UNITED STATES PATENT AND TRADEMARK OFFICE

Office Action Summary

10/823,486

DETAILED ACTION

Fig. 1 – Fig. 2 from Shah (6,595,430)

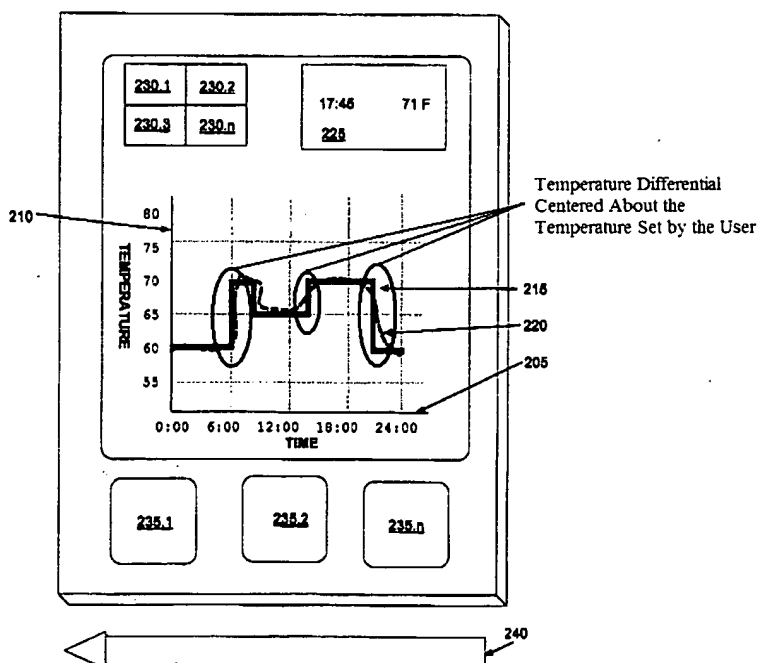
In regard to claims 1 and 18, Shah provides a display where the display is operable to illustrate a range of temperature on the first axis, and a range of times on the second axis (C-4, L-7-10). Referring to Fig. 1, there is also a shaded area defining the temperature differential centered about temperature set by the user.

In regard to claim 2, Shah teaches a step of providing a line indicating the past temperature of at least one area. Referring to Fig. 1, Shah provides a bold line (shaded area) indicating the temperature as 60 degrees between 0:00 and 6:00.

Fig. 2 – Fig. 1 from Ratz et al. (5,203,497)

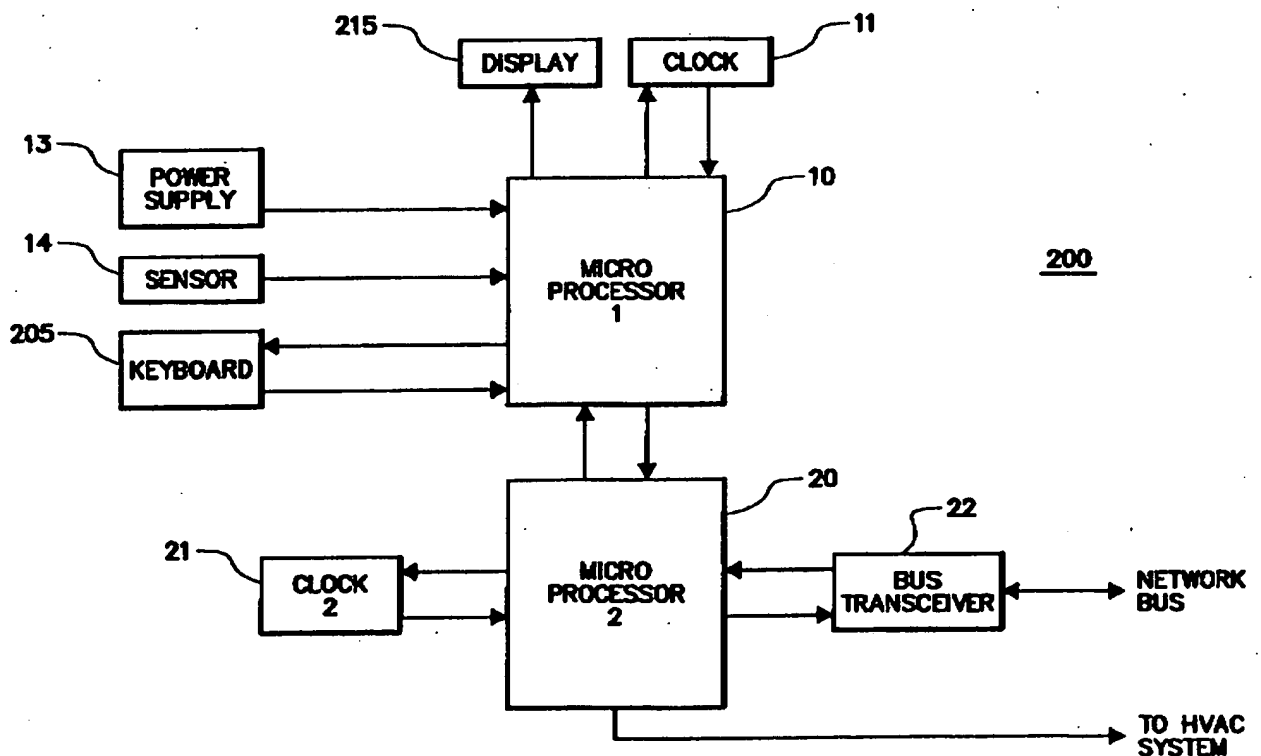
In regard to claim 9, Ratz et al. teach reporting the temperature local to the at least one display to a device located remote from the at least one display (C-2, L-30-32, 57-59). Referring to Fig. 1, one can see that once the temperature is measured it sends signal to microprocessor 1, and microprocessor 1 provides a temperature signal to display (215) and the microprocessor 2. Microprocessor 2 is connected to a HVAC system. Ratz et al. thermostat is on a local area network, therefore it would have been obvious to one having ordinary skill in the art at the time the invention was made to display the temperature at a remote location.
